Item Name: AS350/AS355 Quick Release Basket/Long Cargo Tube Mounting Provisions, Fits LH/RH

DART SERVICE INSTRUCTION

**TO AMEND INSTALLATION INSTRUCTIONS D350-607-3 Rev.D,
INSTALLATION INSTRUCTIONS D350-607-4 Rev. C AND
INSTRUCTIONS FOR CONTINUED AIRWORTHINESS ICA-D350-607 REV. 6**
REF TCCA STC: SH94-14
REF FAA STC: SR00213NY
REF EASA STC: EASA.10016996
REF BRAZILIAN STC: 2007S03-03/-04/-05/-06

A	NEW ISSUE	AJS	14.05.16
REV.	DESCRIPTION	BY	DATE
DESIGN	AJS	DART AEROSPACE LTD HAWKESBURY, ONTARIO, CANADA	
DRAWN	AJS		
CHECKED		DRAWING NO.	REV. A
MFG. APPR.	N/A	DSI 9699	SHEET 1 OF 2
APPROVED		TITLE	SCALE
DE APPR.		LUG REPLACEMENT	NTS
DATE	14.05.16	COPYRIGHT © 2014 BY DART AEROSPACE LTD THIS DOCUMENT IS PRIVATE AND CONFIDENTIAL AND IS SUPPLIED ON THE EXPRESS CONDITION THAT IT IS NOT TO BE USED FOR ANY PURPOSE OR COPIED OR COMMUNICATED TO ANY OTHER PERSON WITHOUT WRITTEN PERMISSION FROM DART AEROSPACE LTD.

FIGURE 1: INSTALLATION OF D4775-041 FWD STRUT

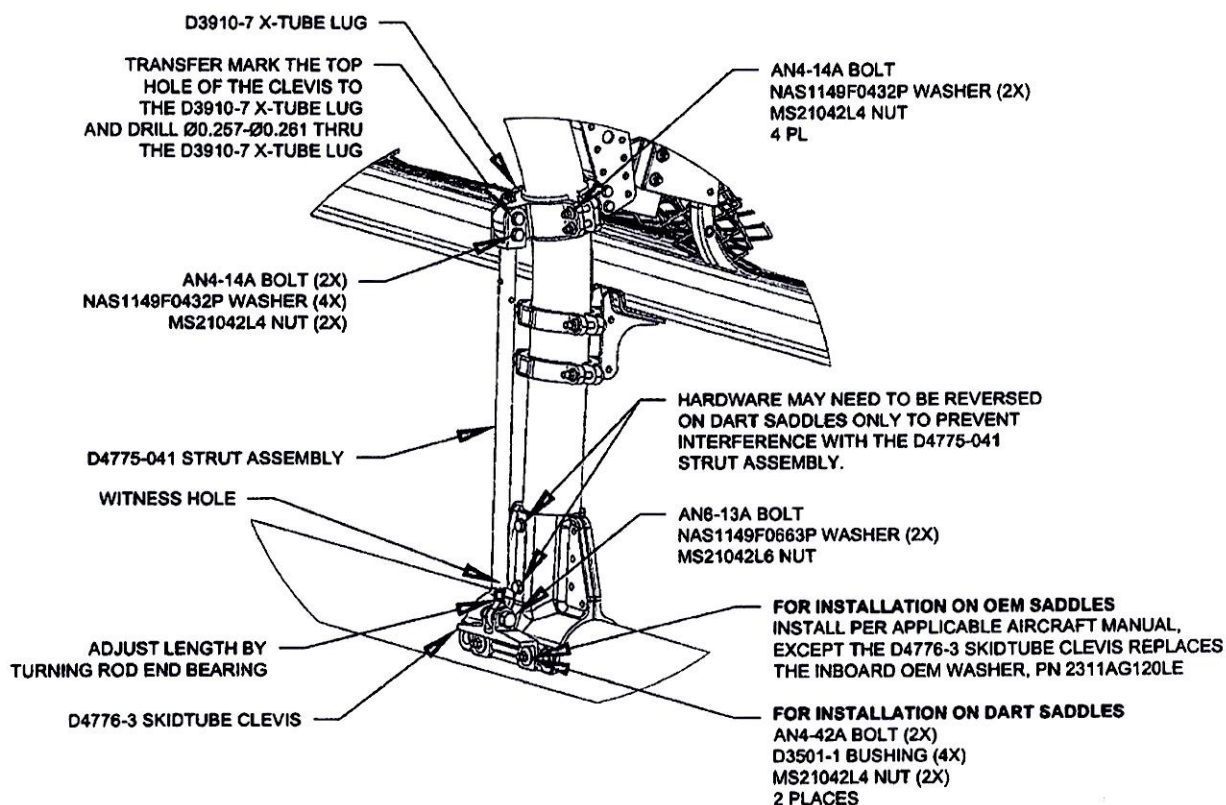
3.1 Substitute the Forward Lower D3910-5 X-Tube Lug with the D3910-7 X-Tube Lug as shown in Figure 1.

3.2 Install the forward D4775-041 Strut Assembly. Transfer mark from the upper hole on the clevis of the D4775-041 Strut Assembly to the D3910-7 X-tube Lug and drill thru the lug $\varnothing 0.257$ - $\varnothing 0.261$ as shown in Figure 1. Touch up chemical conversion coating per MIL-DTL-5541. Check the witness holes located at the bottom end of the D4775-041 Strut Assemblies to ensure that the thread from the rod end extends past the witness hole.
Torque MS21042L4/-4 nuts to 50-70 in-lbs (5.7-7.9 N-m). Torque MS21042L6/-6 nuts to 160-190 in-lbs (18.1-21.5 N-m).
